KINGSTON COURT

Site Plan with Waiver

Street Tree Plan

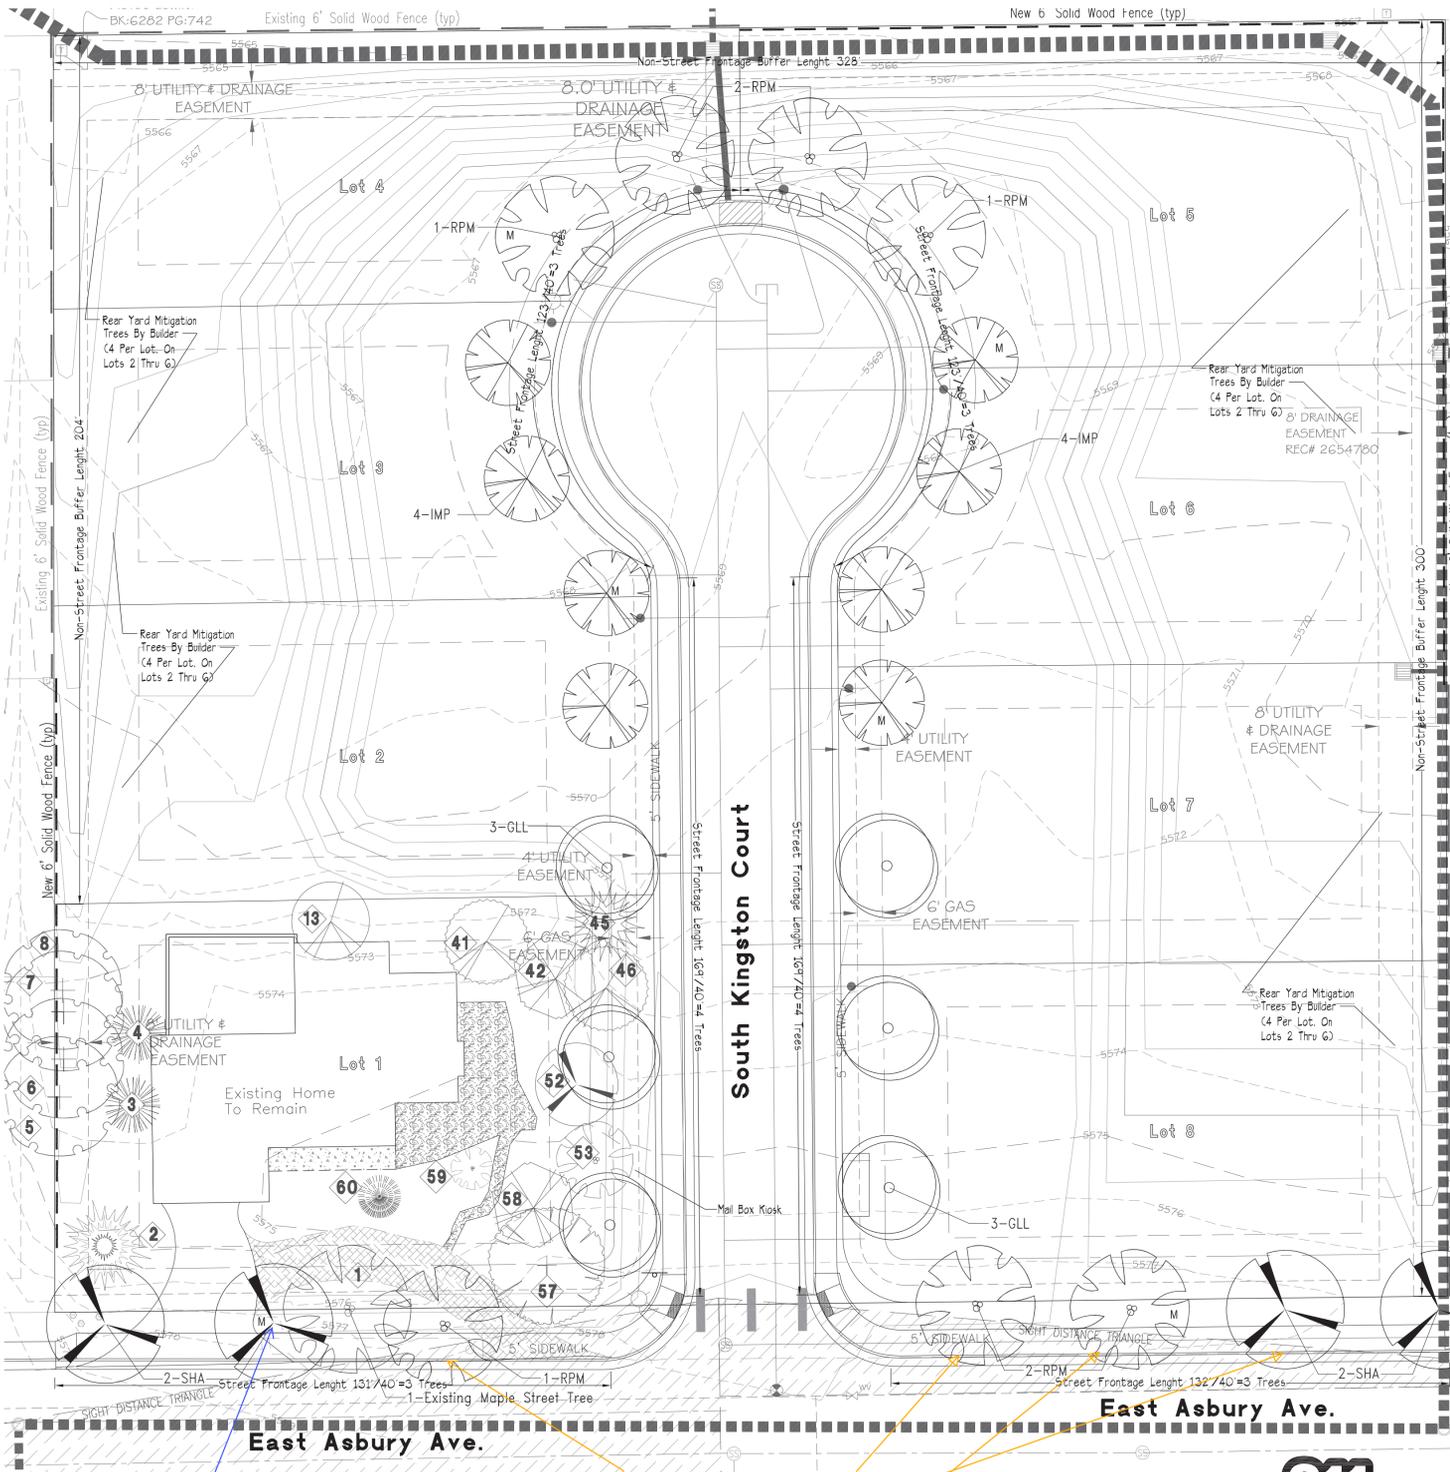
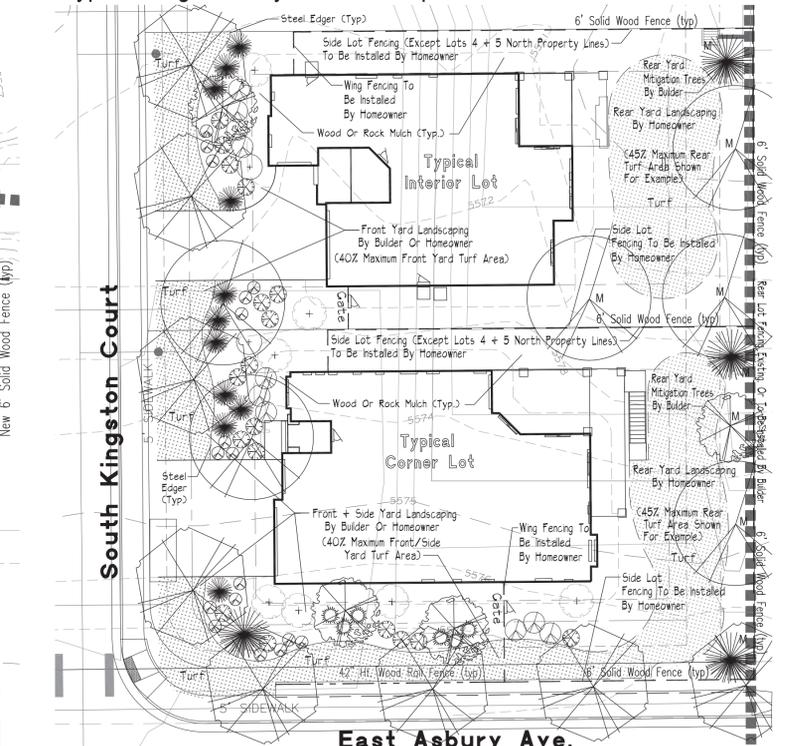
Any proposed landscaping (trees, shrubs, etc.) within the sight triangles must be large enough to provide clear vertical view from 3' to 7'. Up size or use other trees as necessary.

New tree locations were modified slightly, based on new driveway configuration.

A note regarding trees adjacent to the sight triangles was reviewed with Victor Rachael, and added to plan.
